REGIONAL REVIEW NOTIFICATION

ARC REVIEW CODE: R711191

Name of Proposal: Grant Street MUD

<u>Review Type:</u> Development of Regional Impact

Drawing name: T: \019671000_Grant Street DRI\CADD Site Plan\dwg\GRTA Site Plan.dwg DRI Site Plan Nov 15, 2007 4:48pm by: andrea.foard

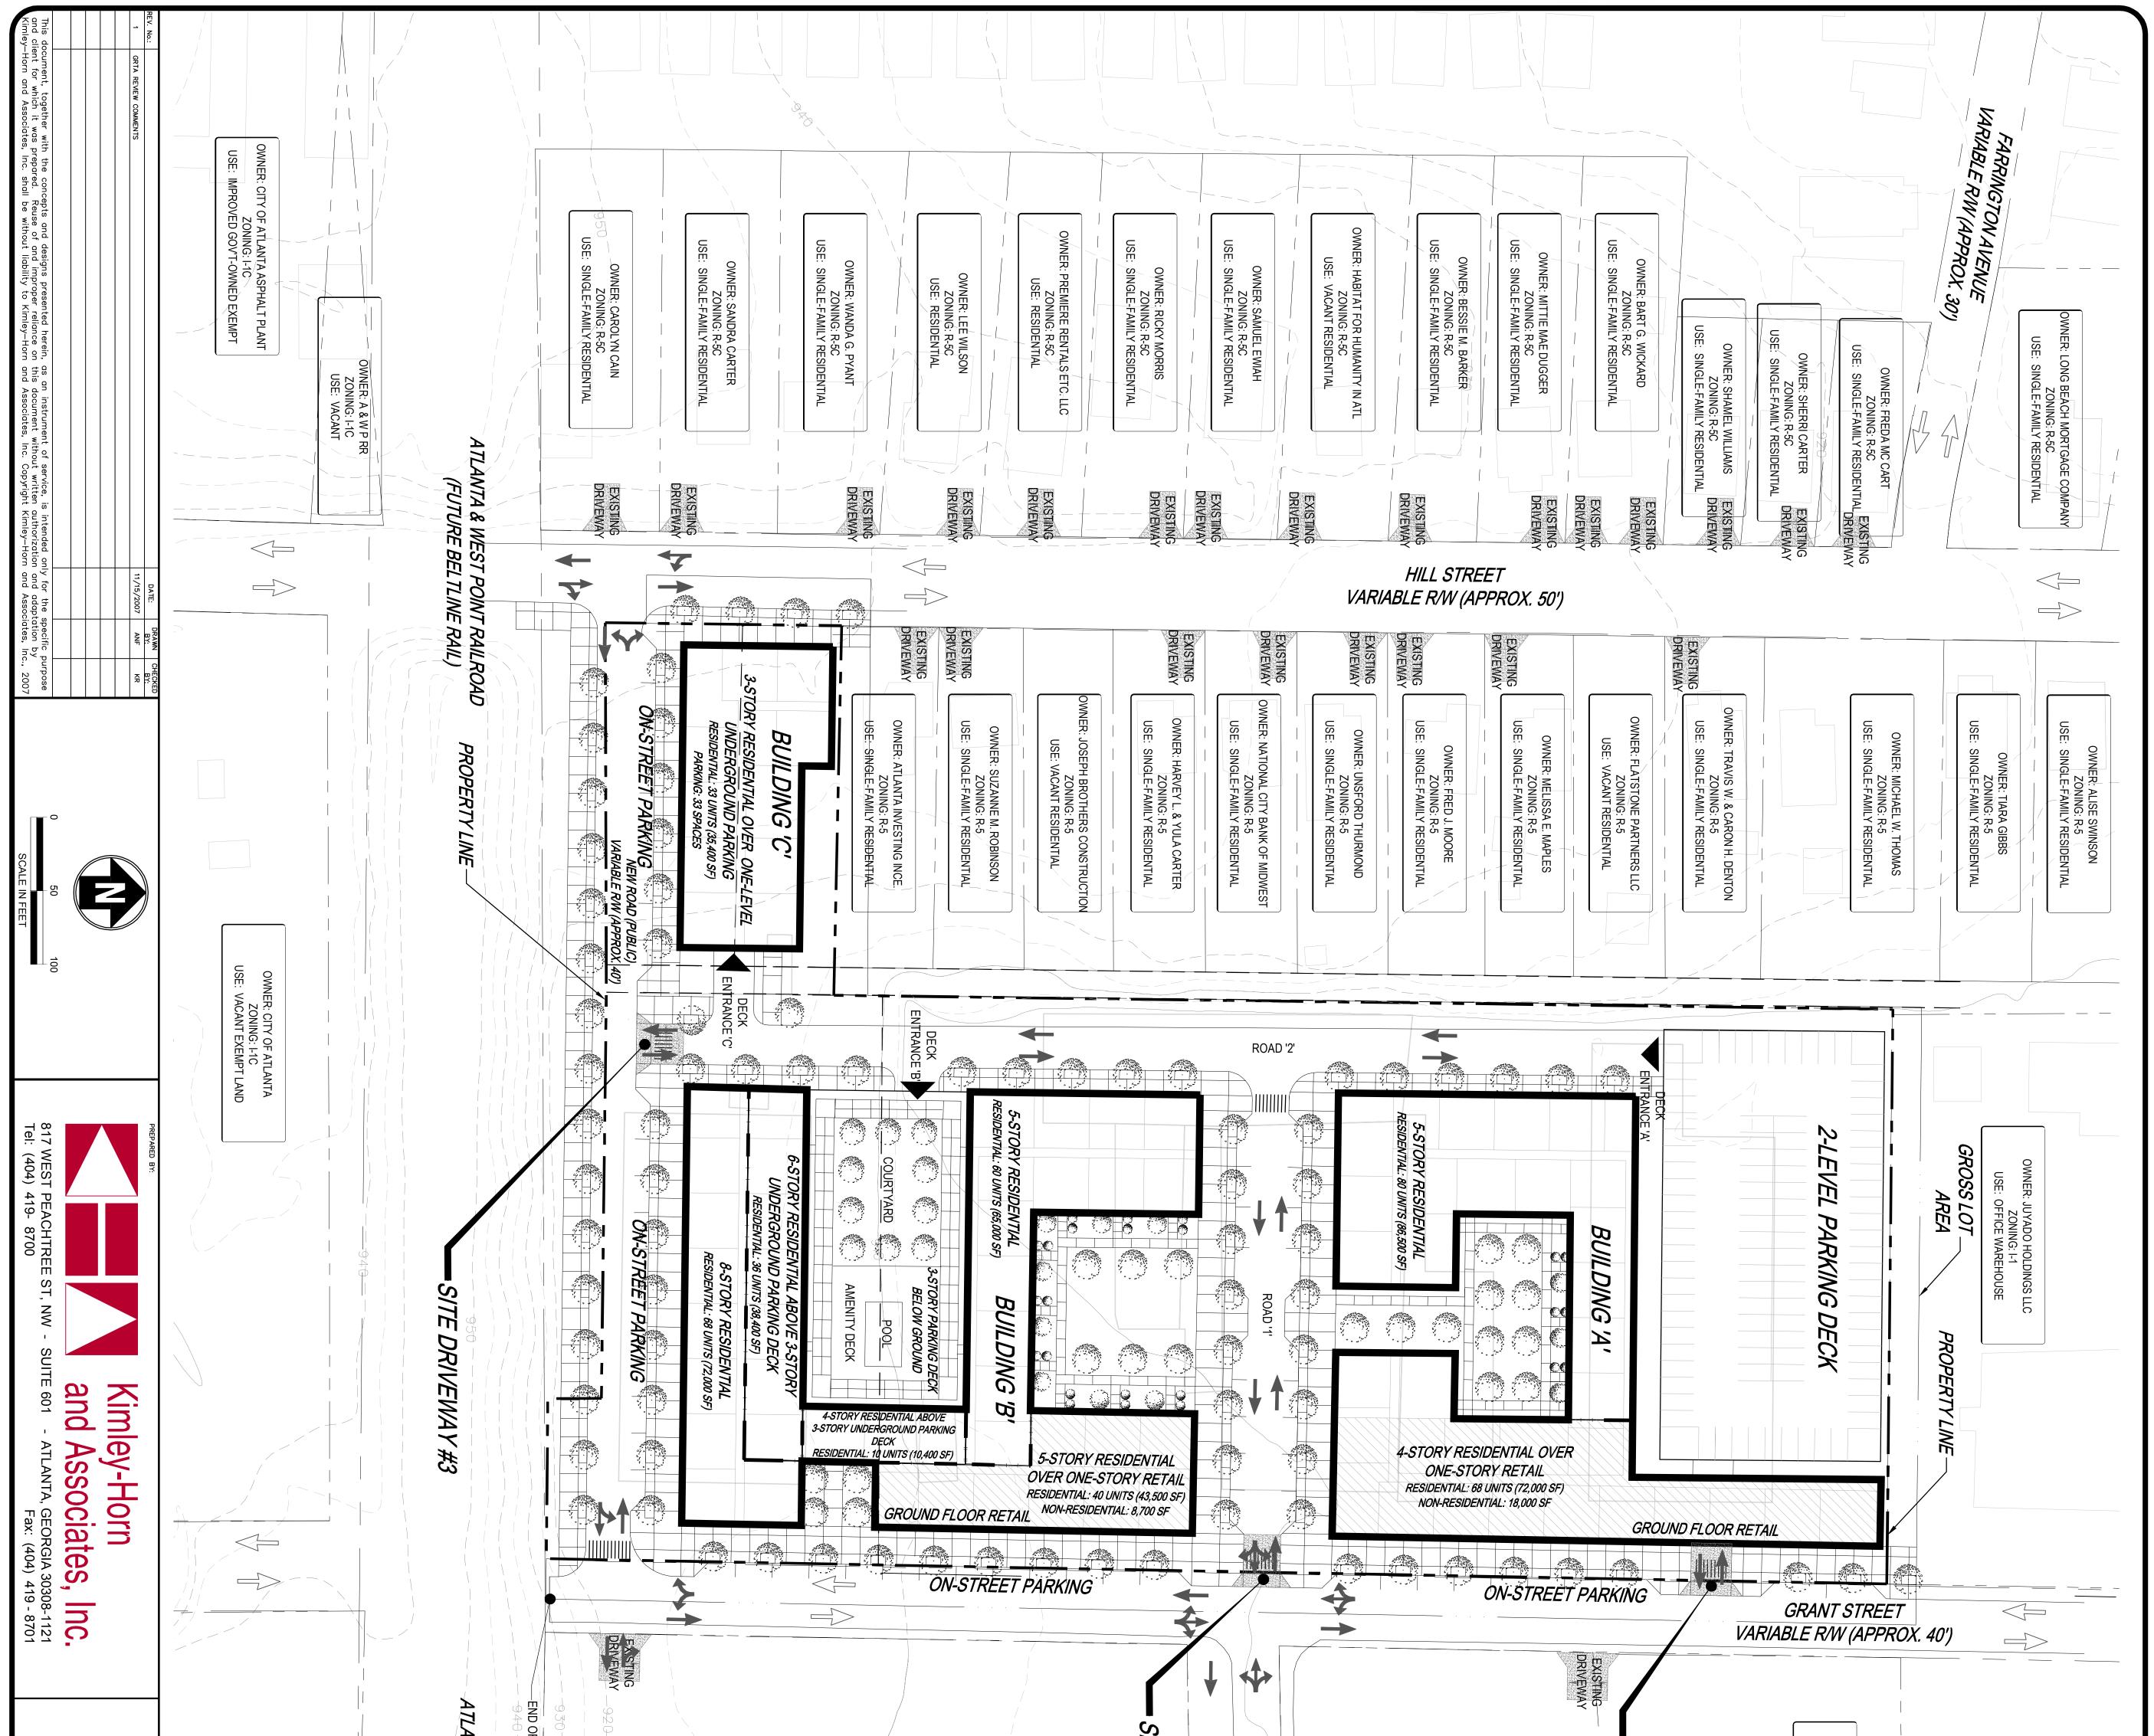
Three site driveways are currently proposed for the development, two onto Grant Street and one onto a new city street that will connect Grant Street to Hill Street along the south side of the property.

• The proposed new westbound approach to Hill Street should consist of one approach lane westbound and one lane eastbound with side-street stop control at the intersection.

• The proposed full-movement driveway at Grant Circle should consist of one ingress lane and one egress lane with side-street stop control.

• The proposed full-movement driveway should consist of one ingress lane and one egress lane with side-street stop control.

• The proposed full-movement driveway should consist of one ingress lane and one egress lane with side-street stop control.

• The mixed use zoning (existing on part of the site and proposed on the rest) MRC requires 1 bicycle-moped parking space per every 5 multi-family residential units. The intensity of the proposed site necessitates at least 50 such parking spaces be provided. However, neither the site plan nor the transportation analysis show any bicycle parking within or adjacent to the development. *The ARC recommends the developer provide dedicate bicycle/moped parking as required by City of Atlanta zoning code.*
